7401 - 7425 HARDING AVENUE MIAMI BEACH, FL HISTORIC PRESERVATION BOARD FINAL SUBMISSION Wednesday, July 3, 2024

TRANSPORTATION UPDATES

7401-7425 HARDING AVENUE

ORIGINAL PLAN

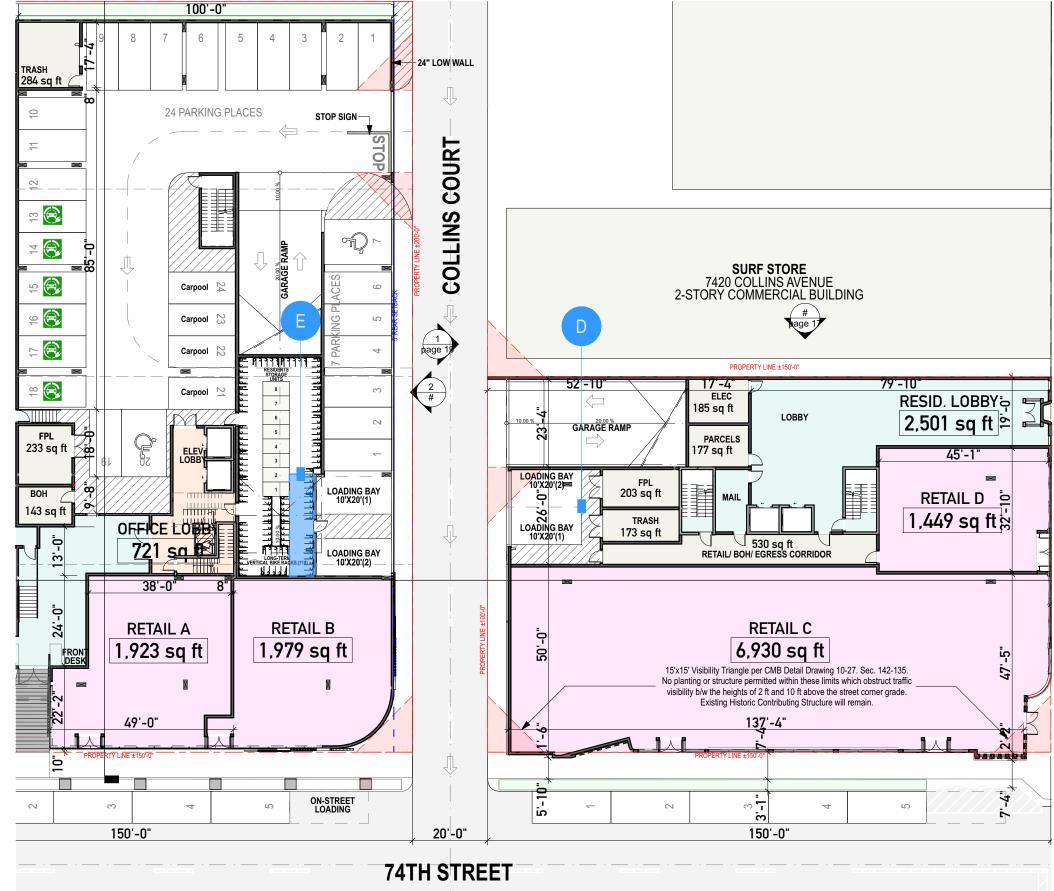
The applicant shall address the following Transportation, Mobility, Concurrency, Delivery, and Parking requirements:

Per the most recently submitted TIA dated April 24, 2024, the applicant shall remove parking space #8 on the east wall of the west garage, and convert parking space #7 to ADA.

b. Per the most recently submitted TIA dated April 24, 2024, the applicant shall include a stop sign for vehicles using the garage ramp to exit the west garage, as well as the appropriate pavement markings.

c. The applicant shall submit the revised west garage ingress/ egress design to the City of Miami Beach Transportation & Mobility Department, in the form of the revised TIA with the updated Site Plan and bicycle parking space locations and

totals, for review and approval prior to the issuance of the building permit.

SITE PLAN

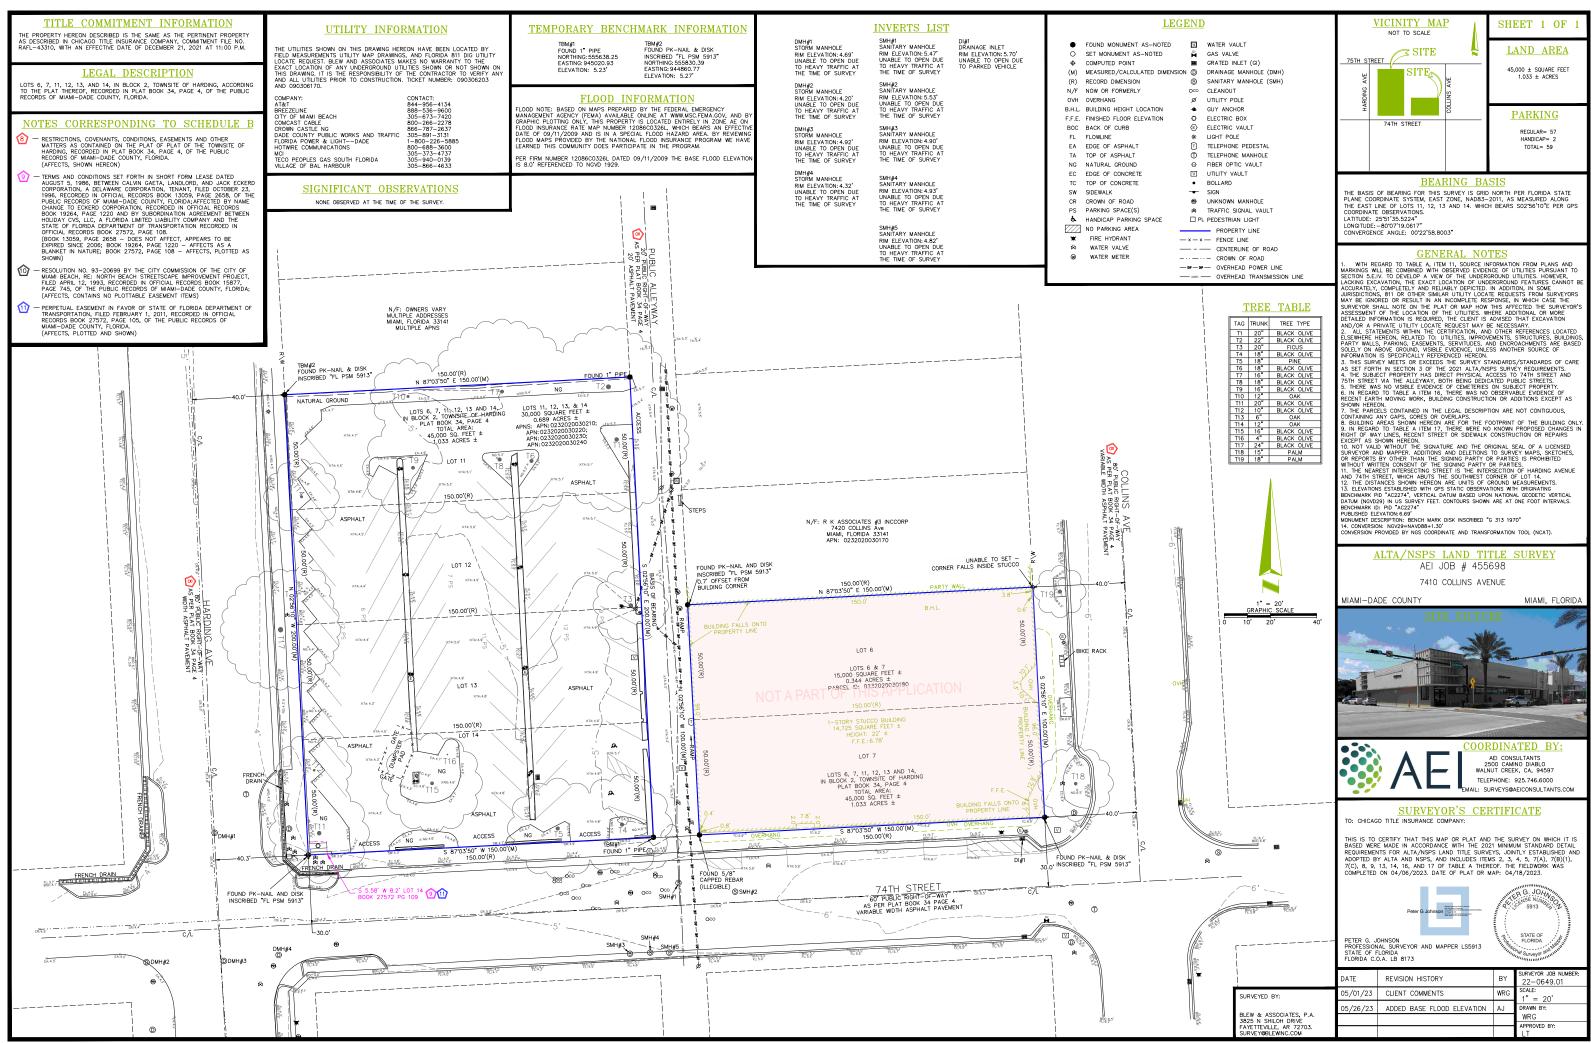
Recommendations:

D Variance Requested All required loading spaces shall be provided on site, unless a variance is granted by the Historic Preservation Board to reduce the number of required loading spaces.

An additional five (5') feet of depth shall be provided to the loading spaces (five feet beyond the 20 foot depth of the actual loading space), in order to allow for the actual loading/ unloading of items, in a manner to be reviewed and approved by staff.
